## AGENDA

- a. Discussion and action on a Site Design Review Permit submitted by Matt Schuenke, Village Administrator, for Phase 2 improvements to the Community Park located at 3234 County Highway AB.
- b. Discussion and action to make a recommendation to the Village Board regarding Resolution 2025-17, a resolution authorizing the Village Administrator to execute a pre-development agreement with Elvehjem Acres LLC and Bliffert Southwest Holdings LLC.
- c. Discussion regarding land division and zoning public notices.

**VILLAGE OF  
McFarland  
SUMMARY SHEET**

We have received the proposed plans for Phase 2 improvements to Community Park, a Village-owned 26-acre site immediately east of CTH B and south of Siggelkow Road. Our comments are shown below, organized by the appropriate document and/or drawing sheet number.

Sheet Number: **C200**

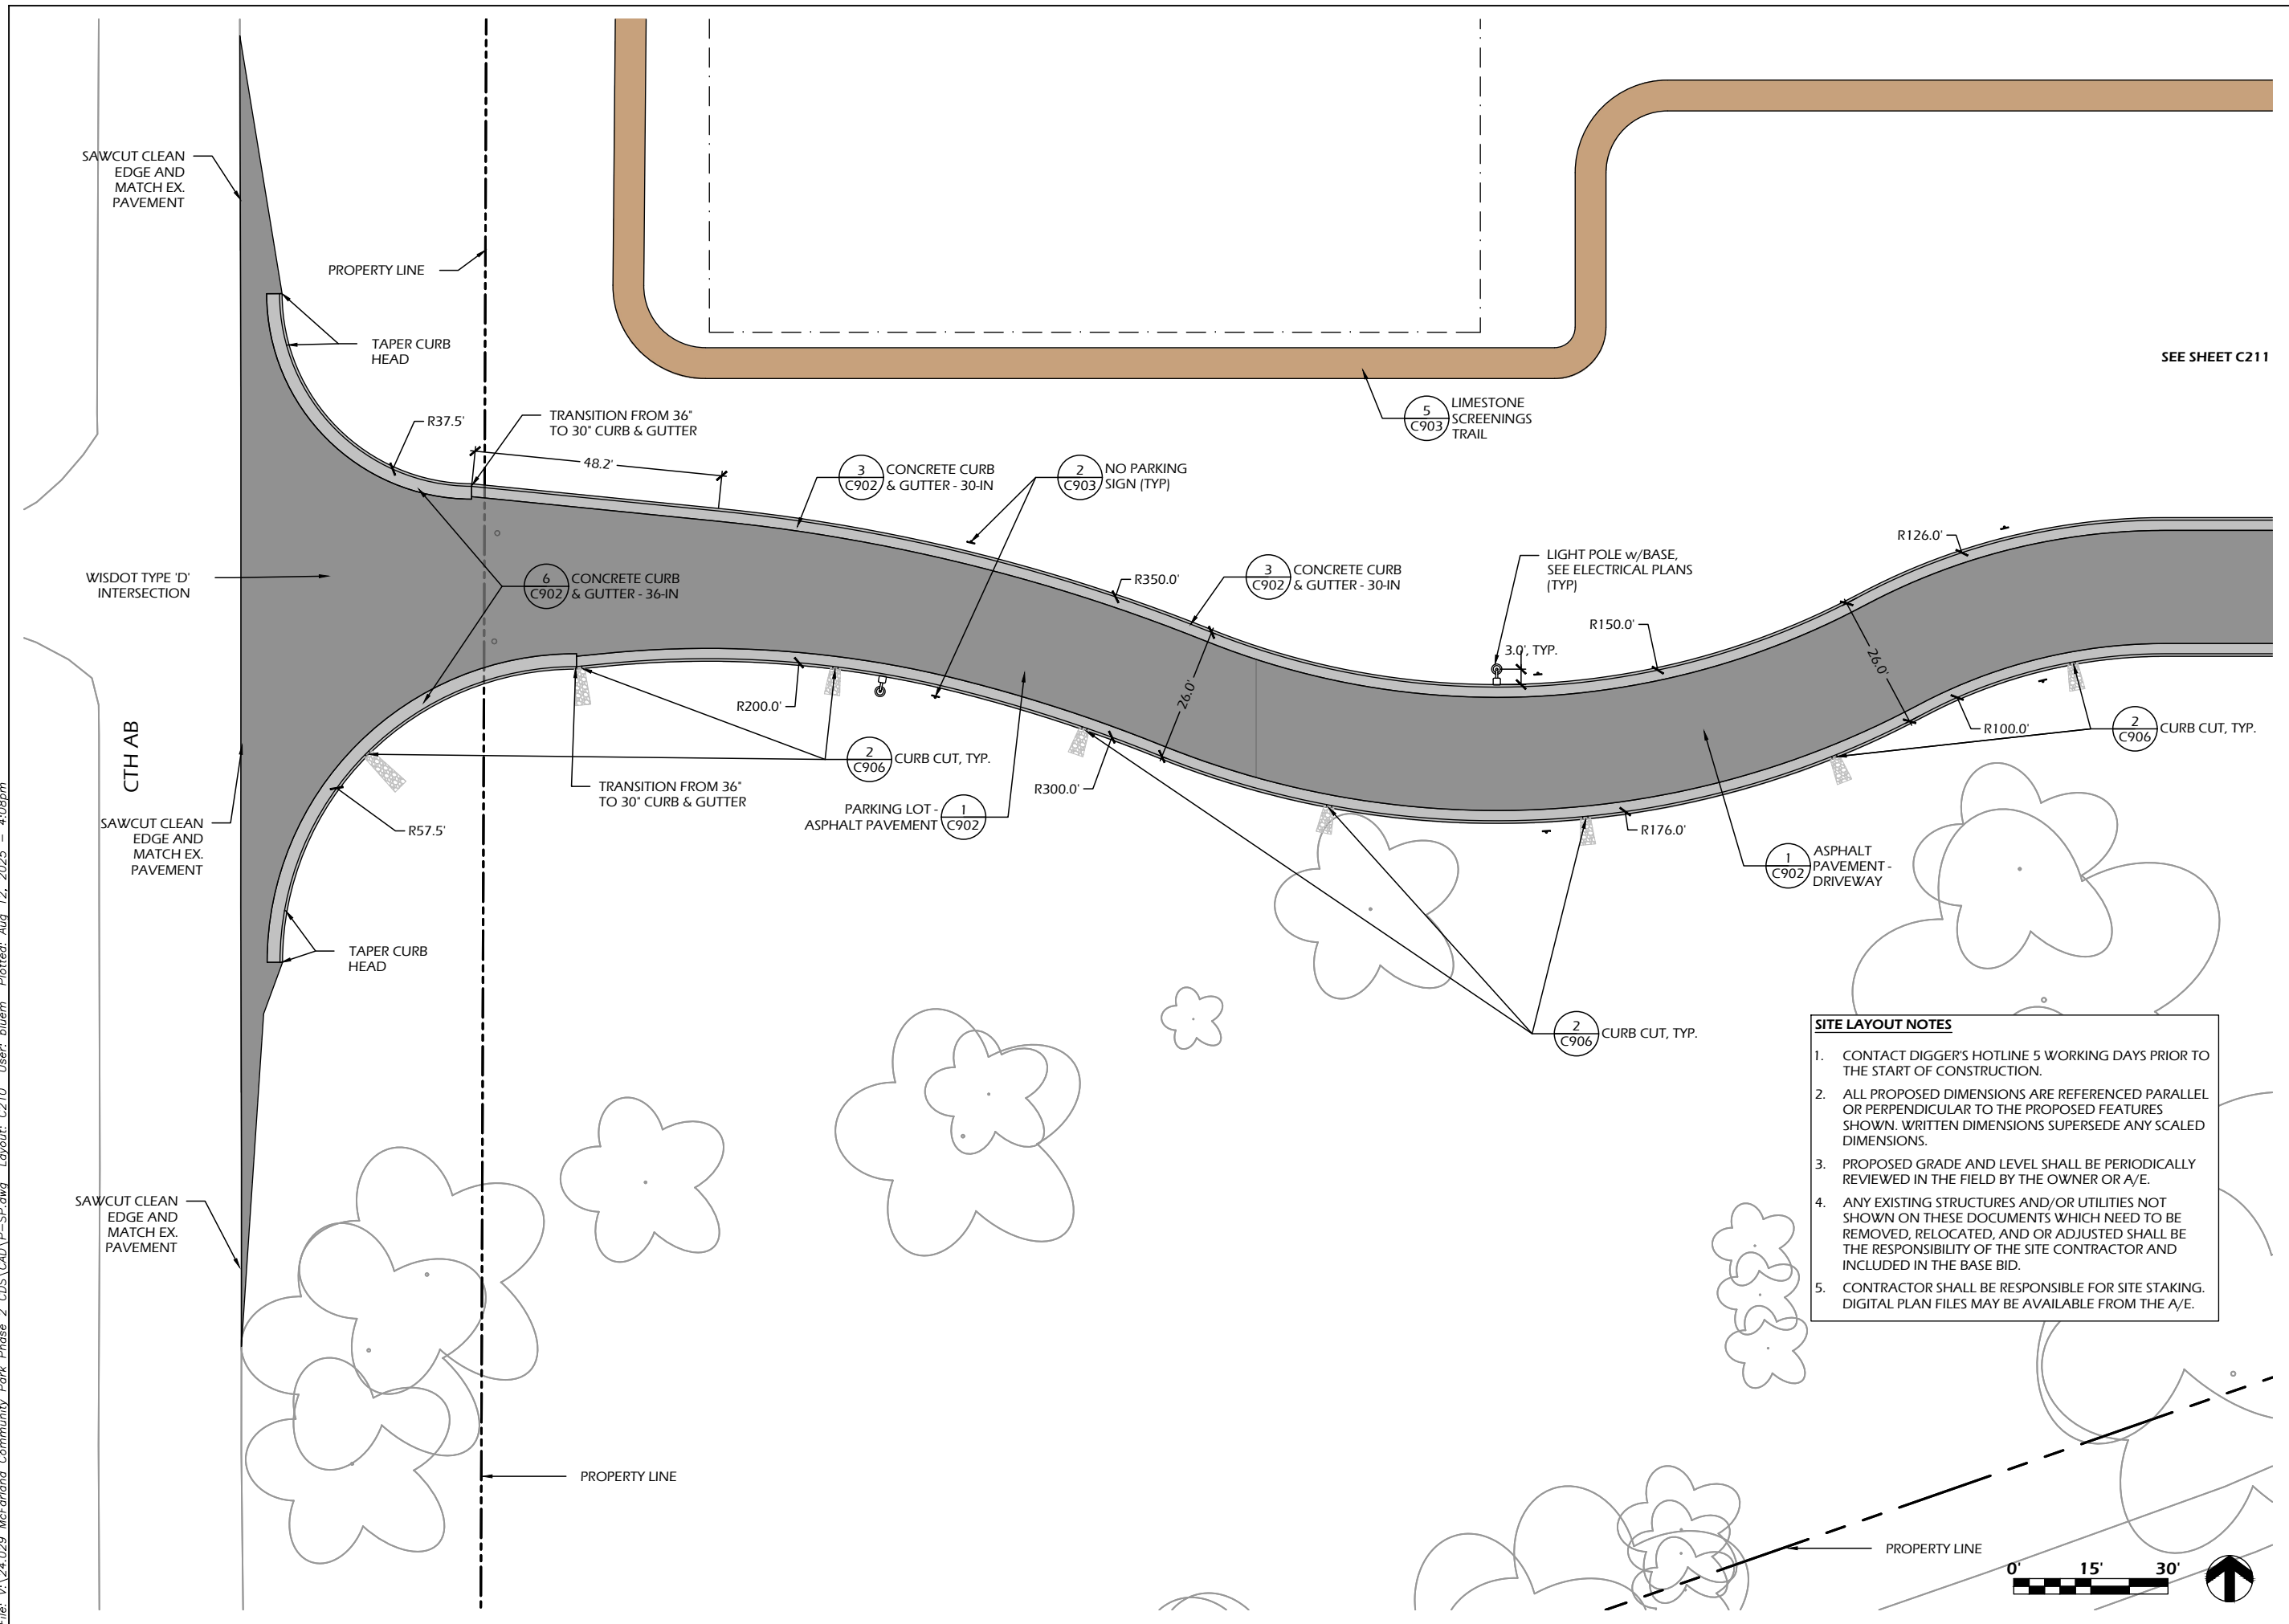
- A network of limestone trails is proposed. We recommend that the radii at 90-degree turns be softened to make future maintenance easier, particularly in the reverse curve sections. Something similar to the radius used near the existing irrigation equipment would be sufficient.
- A portion of the trail near to the shade structure should be moved immediately next to the concrete surface to eliminate an area that may be hard to mow/grow grass.      *A planted landscaping barrier is proposed in this area.*

### **Site Plans**      *Radii on trails have been softened where feasible. Some tighter radii are needed to avoid encroaching into soccer field zones.* Sheet C2

**FIRE ACCESS PLAN**

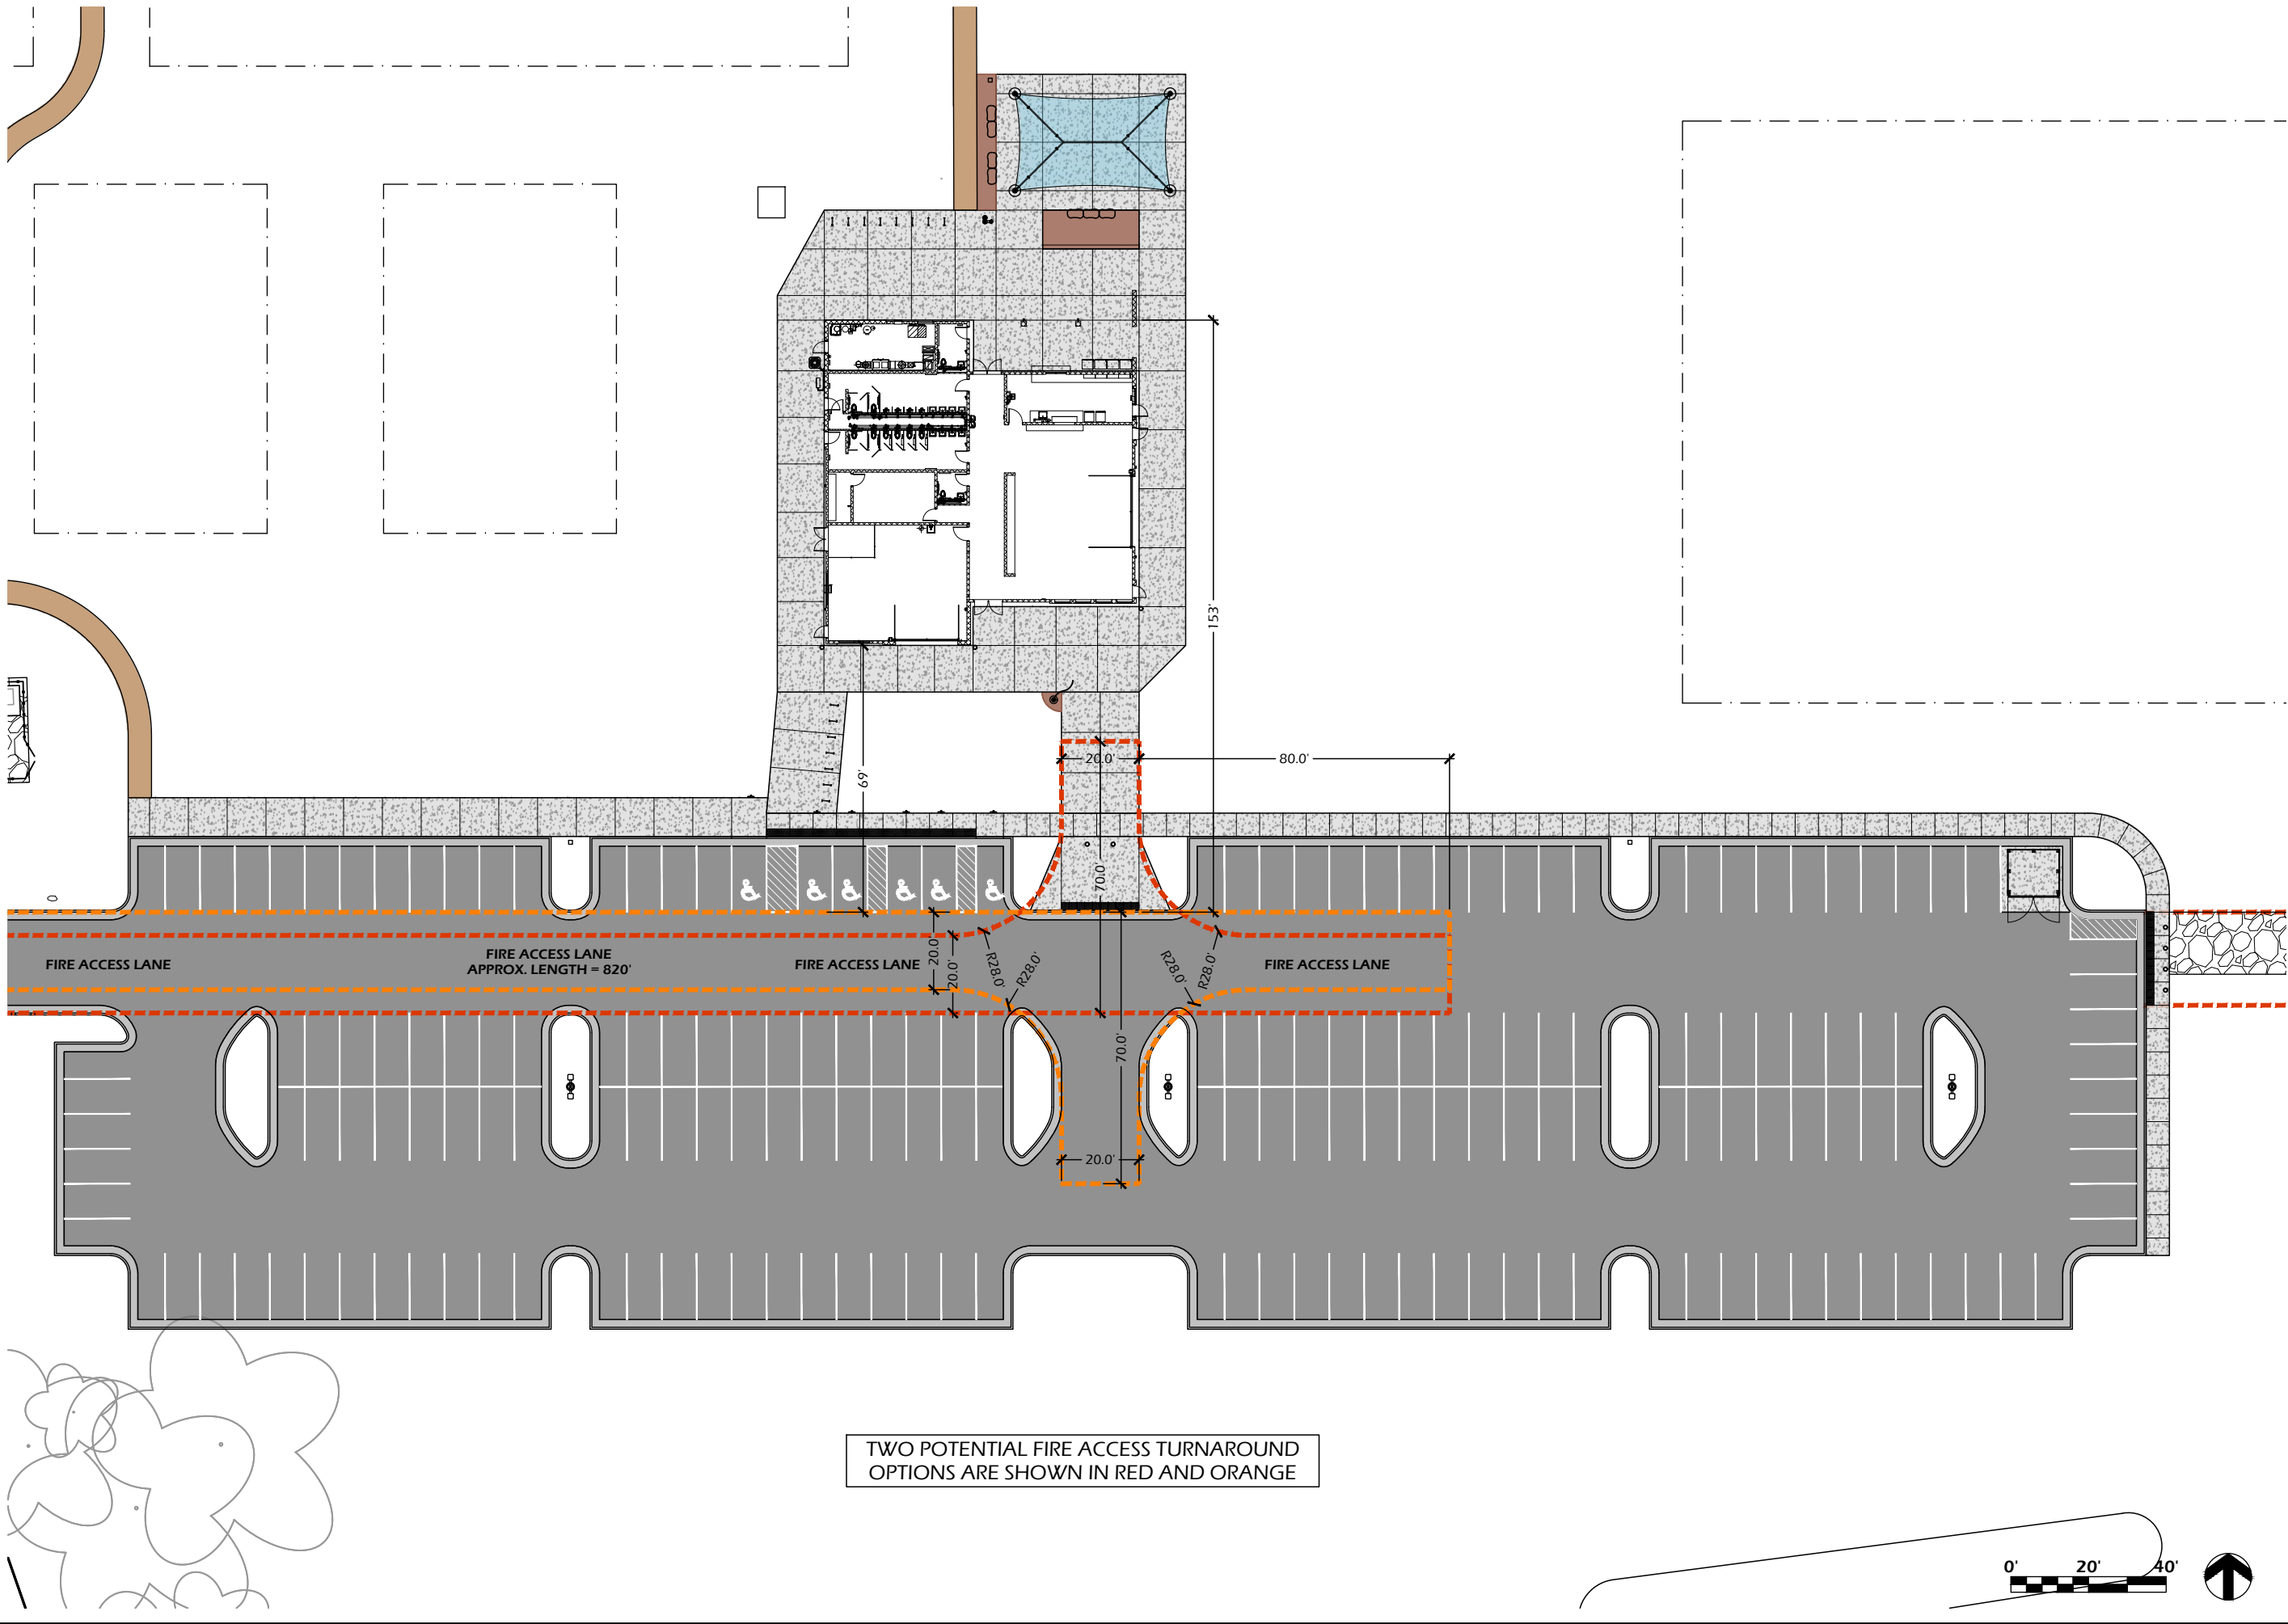
### Sheet C290

- The provided fire department access road serves the proposed building only. The access may need to be extended and revised if future buildings are built.
- The proposed building as currently designed doesn't require automatic fire sprinkler system. If it is modified additional requirements may become required.
